Memorandum

TO: ERCOT Technical Advisory Committee

FROM: Jeff McDonald; Andrew Reimers

RE: IMM Commentary on the 2027 Ancillary Services Methodology

Graphic from ERCOT's AS Methodology Scenario Comparison Tool

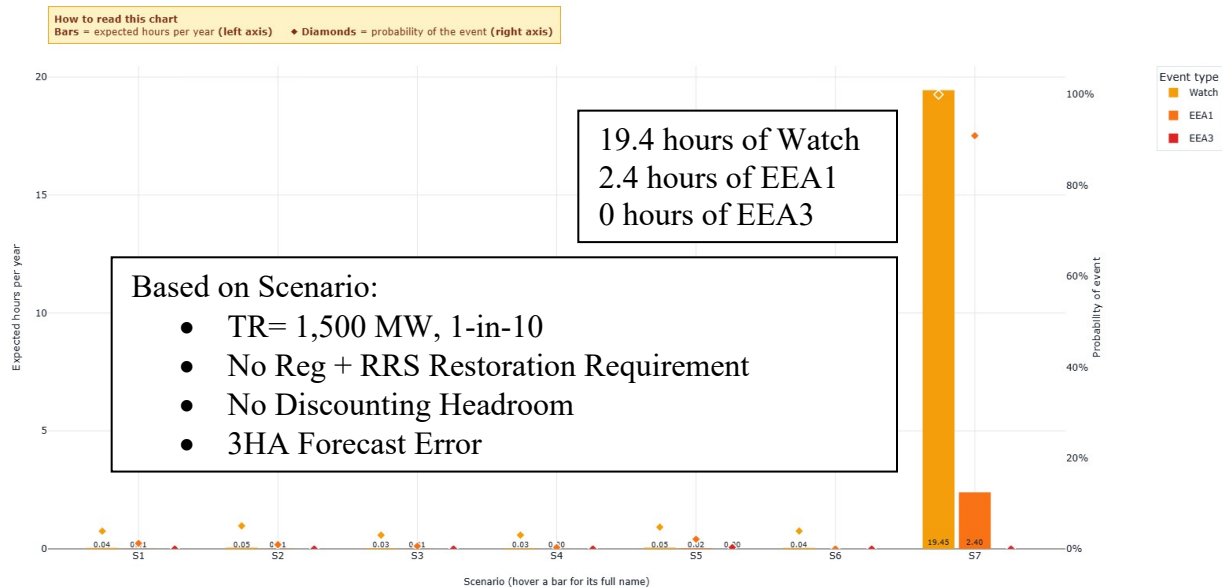
This representation is misleading. ERCOT should instead reference the graphic from the AS Methodology Scenario Comparison tool that evaluates each scenario's procurement target against the risk assumptions underlying that same scenario. Unlike the graphic on slide 15, the alternative comparison does not evaluate every procurement target solely against unduly conservative risk assumptions, including the unrealistic assumption that all unprocured headroom is necessarily unavailable. The following sections explain why some shortage conditions are necessary for proper market outcomes and why ERCOT's risk parameters overstate actual system risk, resulting in excessive procurement targets.

The scenario presented at the end of the previous section projects 19.4 hours of Watch conditions, 2.4 hours of EEA1 conditions, and no hours of firm load shed. The scenario solves for a 1-in-10-year probability of firm load shed, eliminates the Reg Up and RRS restoration requirement, credits all qualifying headroom, and uses a three-hour-ahead forecast-error horizon. Such an outcome, which allows some shortage conditions while avoiding firm load shed, represents the appropriate target for ERCOT and stakeholders. ERCOT's energy-only market relies on shortage pricing to provide generators with the revenues and investment signals needed to support new capacity. A methodology designed to eliminate all shortage conditions would suppress those signals and undermine the market's ability to attract investment, even if it reduced modeled operational risk.
